OHIO TURNPIKE AND
INFRASTRUCTURE COMMISSION

ADDENDUM NO. 3

CONTRACT NO. 39-14-02

RIGHT TWO (2) LANES AND SHOULDER RECONSTRUCTION
MILEPOST 159.80 TO MILEPOST 164.82
CUYAHOGA COUNTY, OHIO

| CONTRACT 39-14-02 SHEET 210 OF 414 | | | |

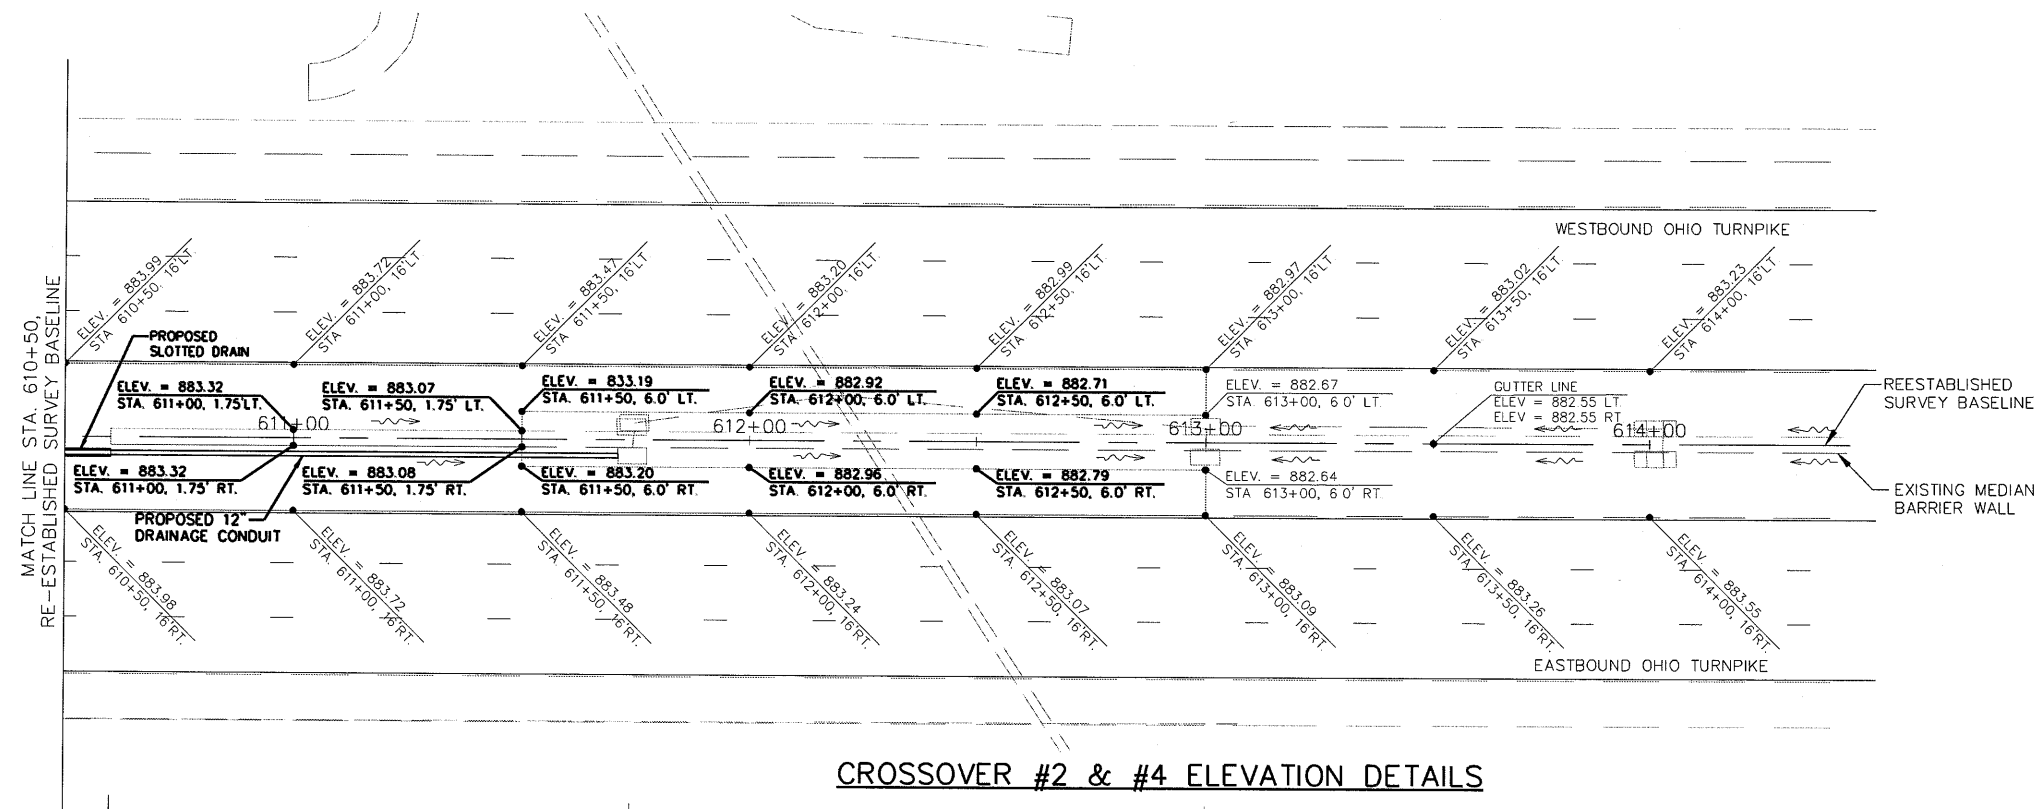
Q#23 Plan pages 207 & 210 show 12" conduit being connected from the existing catch basins to the proposed trench drain, how is this conduit paid for?

Plan Sheet 210 of 414

General Note 4 is modified via this Addendum No. 3 as follows:

A#23 The conduit necessary to temporarily connect the trench drains to the existing catch basins is considered incidental to Maintaining Traffic in the crossover areas. All costs associated with this Work shall be included in Item 615 – Pavement for Maintaining Traffic, Class A, As Per Plan.

- “3. TEMPORARY PAVEMENT SHALL BE PAID FOR UNDER ITEM 615 –PAVEMENT FOR MAINTAINING TRAFFIC, CLASS A. TEMPORARY EMBANKMENT SHALL BE PAID FOR UNDER ITEM 615 – ~~ROADS~~ **PAVEMENT** FOR MAINTAINING TRAFFIC, CLASS A, AS PER PLAN.”

| OHIO TURNPIKE AND INFRASTRUCTURE COMMISSION | |
|--|---------------|
| O.T.I.C. STANDARD DRAWING | CBR-5 |

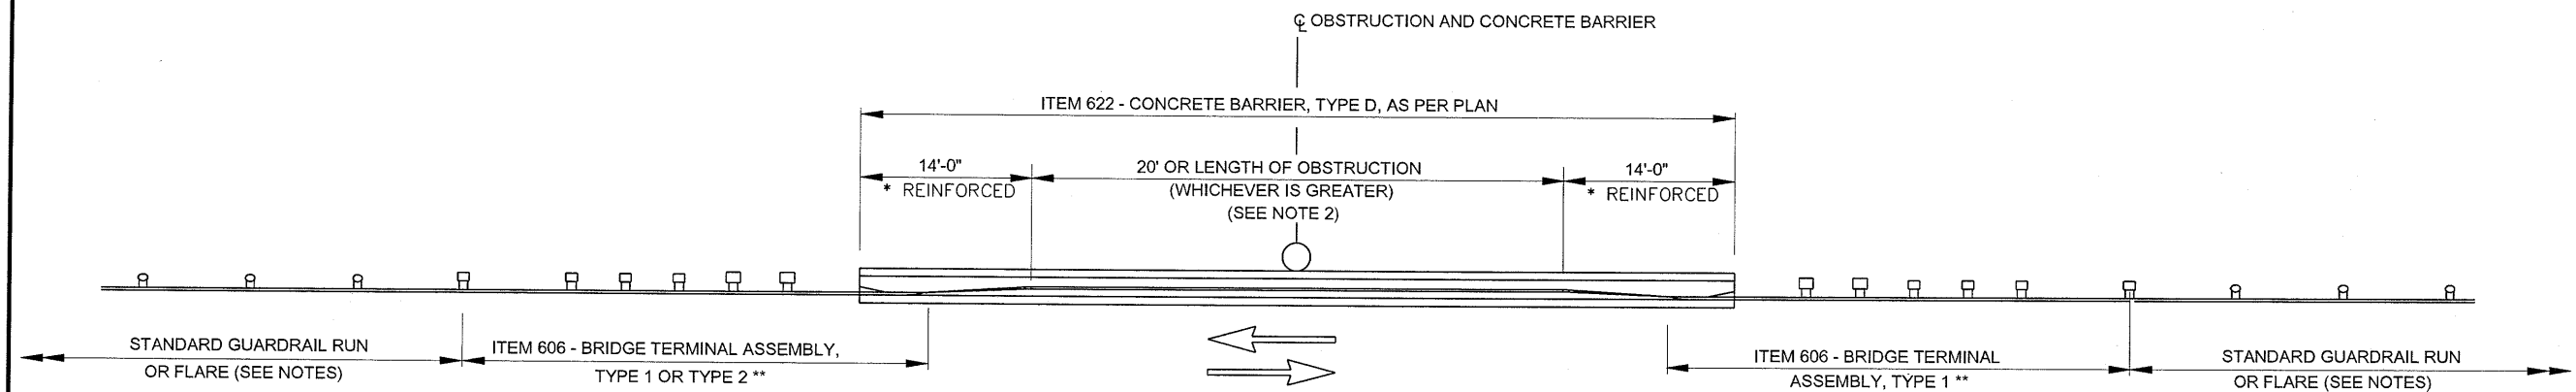
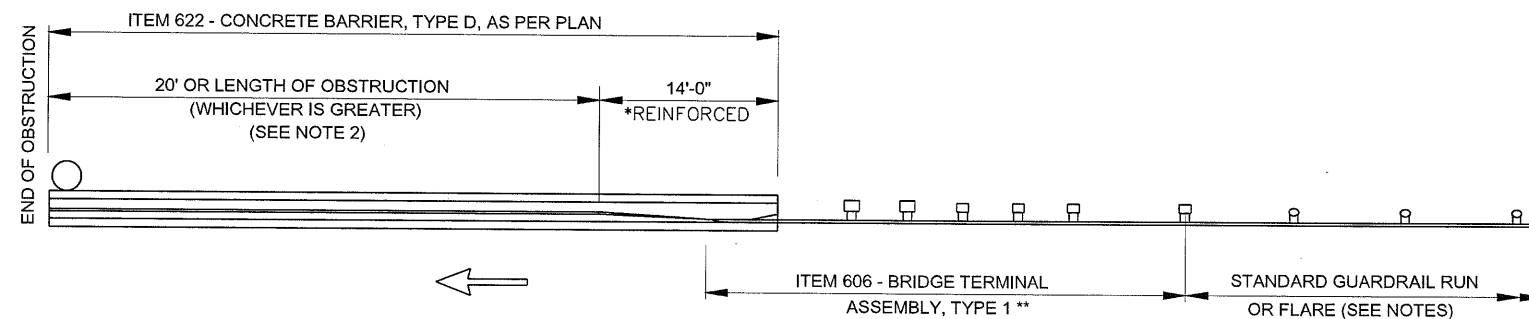
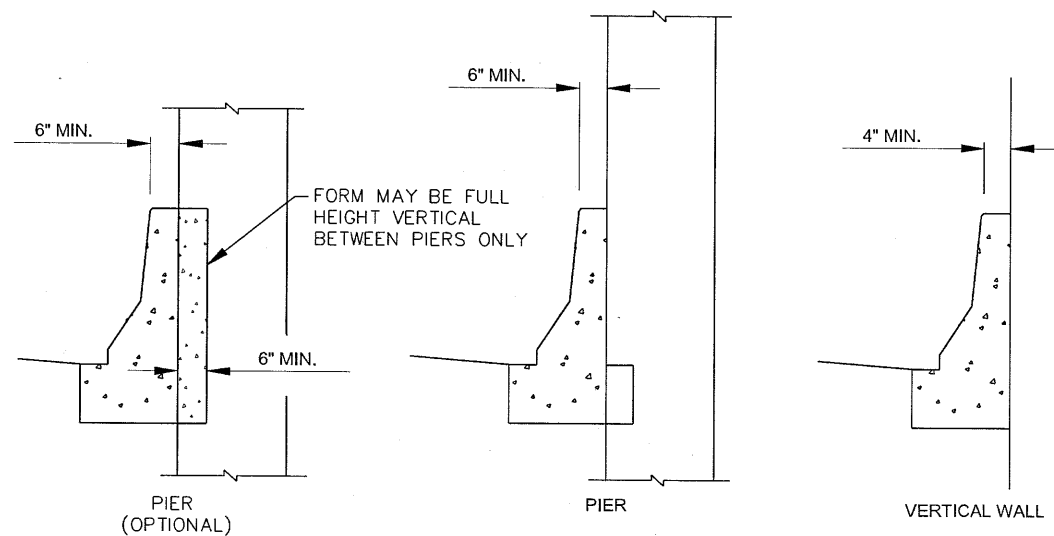
Q#26 Page 14 of the general notes under Item 622 – Concrete Barrier, Type D, APP, references standard drawings CBR-5 & CBR-6. These were not included in the plan set and are also not listed on the front page of the plans. Could you please provide these standard drawings?

A#26 Yes, OTIC Standard Drawings CBR-5 and CBR-6 are added via this Addendum No. 3.

Ohio Turnpike and Infrastructure Commission Standard Drawings **CBR-5** and **CBR-6** are added and incorporated in the Contract Documents.
